Service Bulletin

Subject: Excessive Oil Consumption – Perform Oil Consumption Test and/or Install Piston and Piston Ring Kit

Models: 2010-2013 Buick LaCrosse
2011-2013 Buick Regal
2010-2013 Chevrolet Equinox
2010-2013 GMC Terrain
Equipped with 2.4L Engine (RPOs LAF, LEA)

This bulletin replaces PIP5025F to advise engine replacement is no longer necessary if "zebra stripes" are present and to outline a related repair procedure. Please discard PIP5025F.

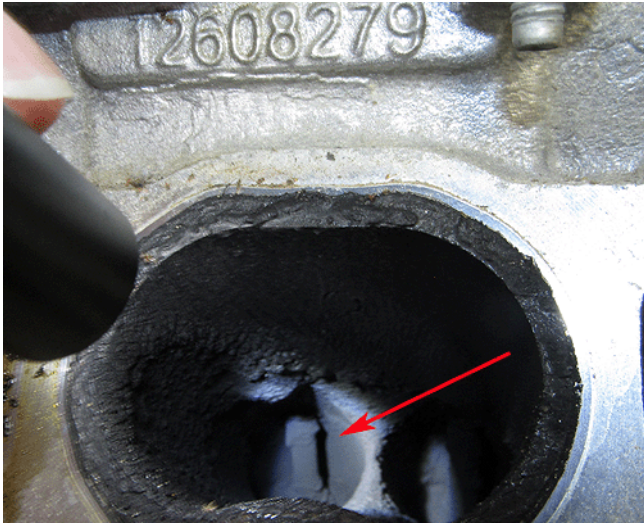
Note: Returned oil consumption engines have been reviewed at engine tear down. It has been determined that these components do not need to be replaced:

- Camshafts and roller follower will have wear markings. This is normal and do not need to be replaced (refer to picture above).

- Valves stems may have deposits build up on them. These deposits are characteristic of a direct inject engine. The valves stems do not need to be cleaned as they are not affecting engine performance (Refer to picture above).
- The oil pump does not need to be replaced as the low oil level operation did not damage the pump.
- The camshaft actuators do not need to be replaced at this time. The vehicle may have arrived with the engine knocking. If the oil level was 1 1/2 - 2 quarts low, it was the lack of oil causing the actuator noise.
